SUTHERLAND SHIRE COUNCIL ASSESSMENT REPORT

| Proposed Development: | Refurbishment and restoration of Heathcote Hall, construction of 35 townhouses and 20 apartments, associated landscape works and 56 lot strata subdivision |
| Street Address: | Lot 1 DP 725184, Lot 2 DP 725184 (No. 1-21) Dillwynnia Grove, Heathcote |
| Report prepared by: | Lisa Pemberton, Assessment Officer Sutherland Shire Council |

Amended site layout as proposed in amended plans identifying the carriageway and Heritage Curtilage

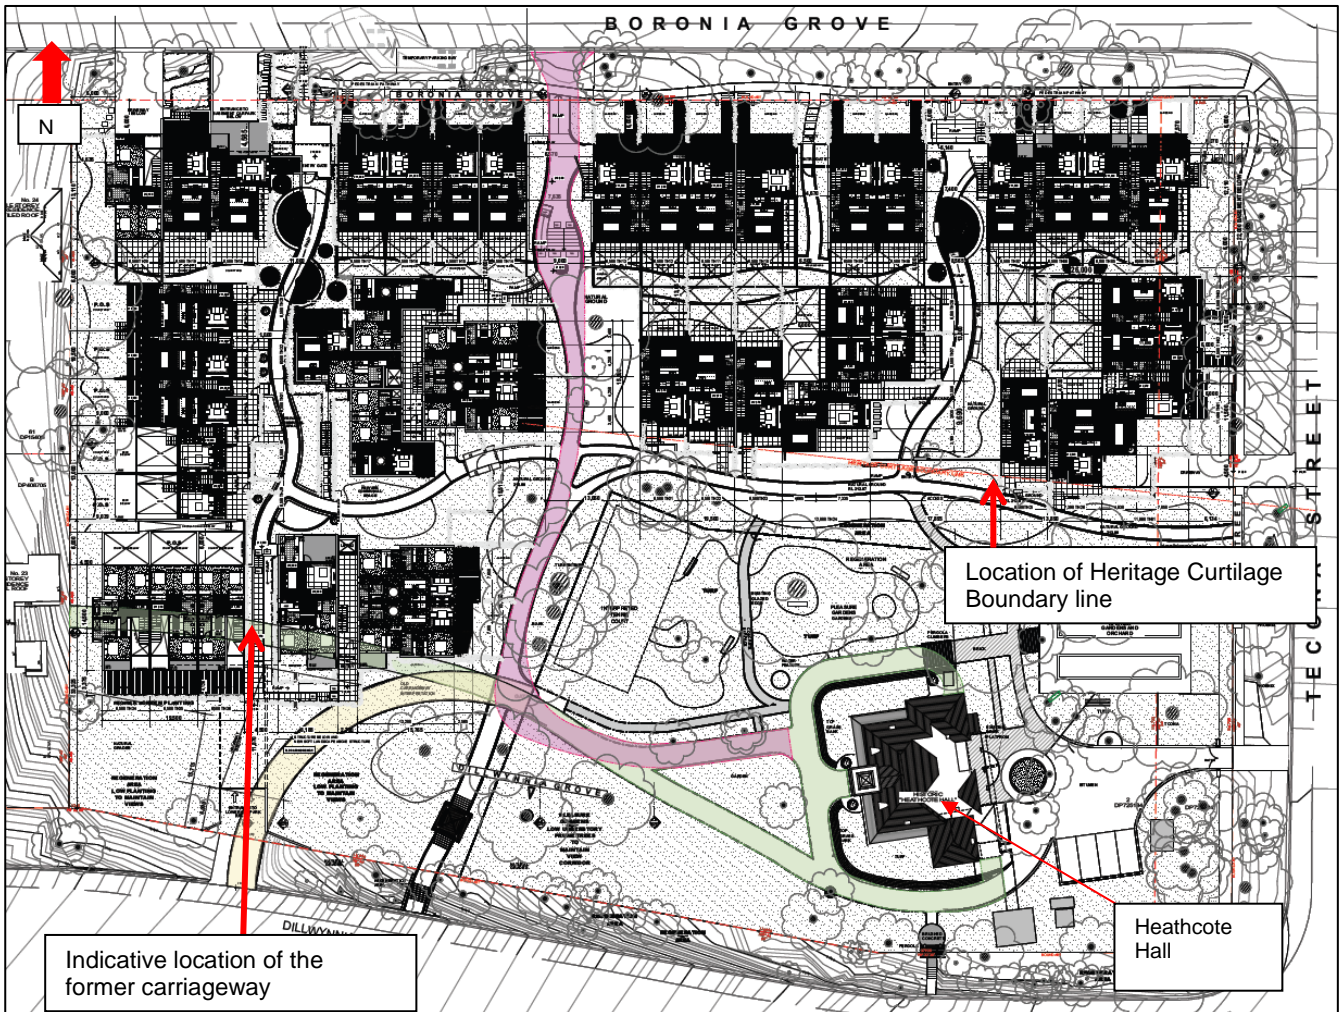
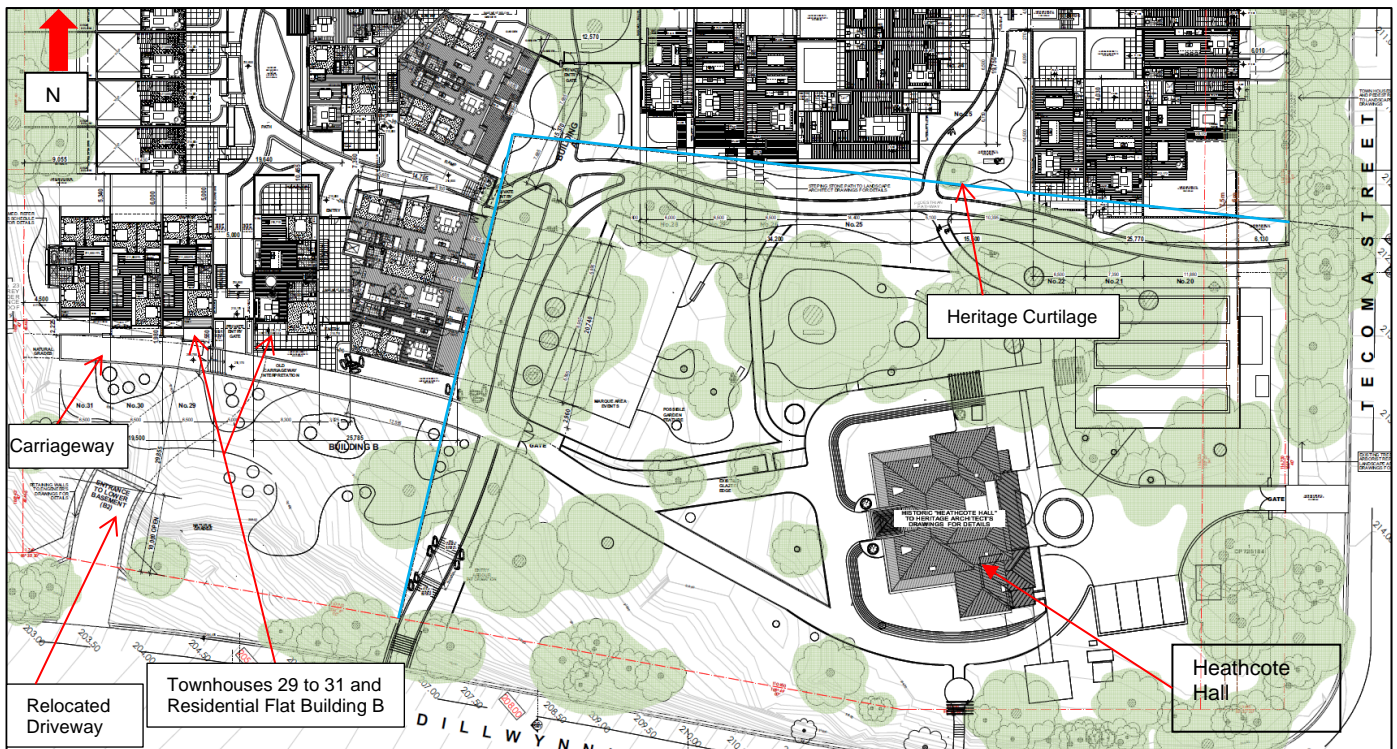
However, there were design modification imposed in these original GTAs, whereby the Heritage Council required amendments to various aspects of the development as they encroached into the setback and curtilage areas as identities in the CMP. Encroachments can be seen below on the original plan submitted with the application. Further the setbacks and curtilage were not clearly identified on the plans.

The original GTAs would require design modification. However, these would not be required until Section 60 stage (post any consent) rather than at development assessment stage. As a result of these general terms there was no certainty for Council regarding the future location of the dwellings and other built form.

Council advised the Heritage Council that any changes required by the GTAs would need to be resolved prior to determination. The Heritage Council attended the workshop held at Council, and provided some advice and clarification to both Council and the applicant regarding the general terms. Of particular importance was that the applicant would be required to accurately overlay the setbacks and curtilage as identified in the images from the CMP above, as well as locate dwellings further north to align with the curtilage and setbacks. The Heritage Council advised they were satisfied with retaining a driveway entry to the basement from Dillwynnia Grove, subject to a suitable redesign and the driveway being relocated as far west as possible, to minimise visual impact of this entry. The applicant was advised by the Heritage Council that the carriageway should be kept free of all above ground structures.

In response the applicant relocated a number of dwellings further north to address the GTAs. In particular Residential Flat Building B and Townhouses 20-31 were repositioned further north, as can be seen on the plan below.

Residential Flat Building A and B when viewed from Dillwynnia Grove (as originally proposed) with Residential Flat Building B in the foreground.

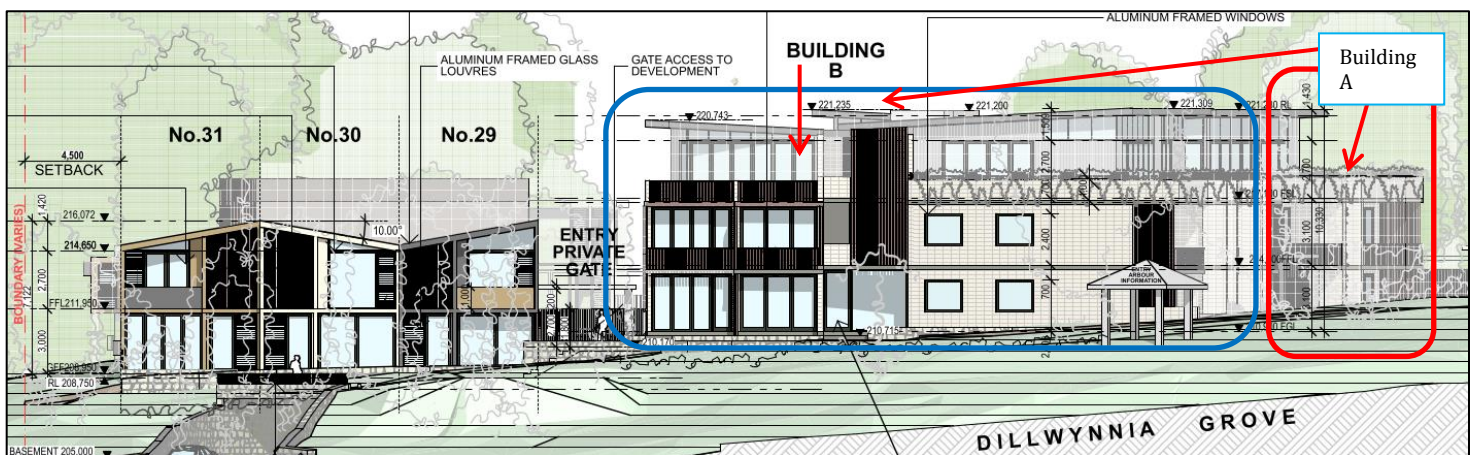
As seen in the figures below the height of Building A as per the original plans and original Clause 4.6 variation request measured 8.8m to the roof at its highest point and 9.8m to the lift overrun. Buildings A and B can be seen below as originally proposed, with Building B below the 8.5m height limit and presented in a form not unlike the town houses in bulk and scale.

Several concerns were expressed in Council's letter to the applicant, the first GTAs issued by the Heritage Council and follow up workshop and meeting. These matters included the non-compliant height of Building A; encroachment of the heritage curtilage contained within the Conservation Management Plan (CMP); and the reduced setbacks along Boronia Grove.

The proposed height breaches are contrary to the objectives set out in Clause 4.3 of the SSLEP2015 above. The development does not provide a transition in building scale or minimise impacts upon visual intrusion, this include to the areas of high heritage significance within the site. In particular the height of Building B and townhouses 30 and 31, where these dwellings have not provided an adequate response to the bulk and scale of the site, and the impacts these buildings will have upon the streetscape, adjoining properties and the heritage of the site itself.

There is a public benefit to maintain the height development standard of Residential Flat Building B and Townhouses 30 and 31 in the circumstances of this case. Building B and Townhouses 30 and 31 will be required to be reduced to have a height no greater than 8.5m. This reduction in height is to provide for a transition in bulk and scale down to the adjacent high significance heritage area (as per the CMP), to the Heathcote Hall and to the adjacent low density dwellings to the south, across Dillwynia Grove. (See annotated plan in **Appendix L**).
